TOWN OF GLASTONBURY BID NO. GL-2010-52 WESTERN BOULEVARD CONNECTION

<u>ADDENDUM NO. 1</u> JULY 1, 2010

PLATE NO. 20

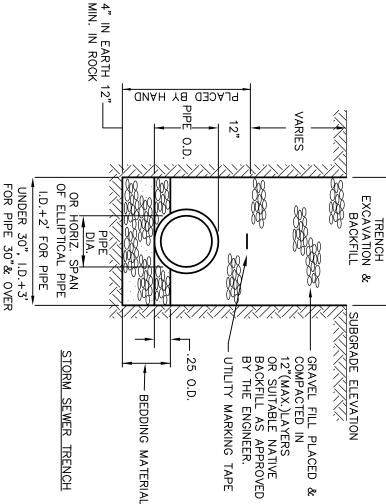
ITEM 2: TRENCH DETAILS FOR STORM DRAIN, UNDERDRAIN, AND SANITARY SEWERS

The attached Town of Glastonbury Standard Details, including Plate No. 20 entitled "Trench for Storm Drain and Underdrain" and Plate No. 30 entitled "Typical Trench for Sanitary Sewers" are hereby made a part of this contract.
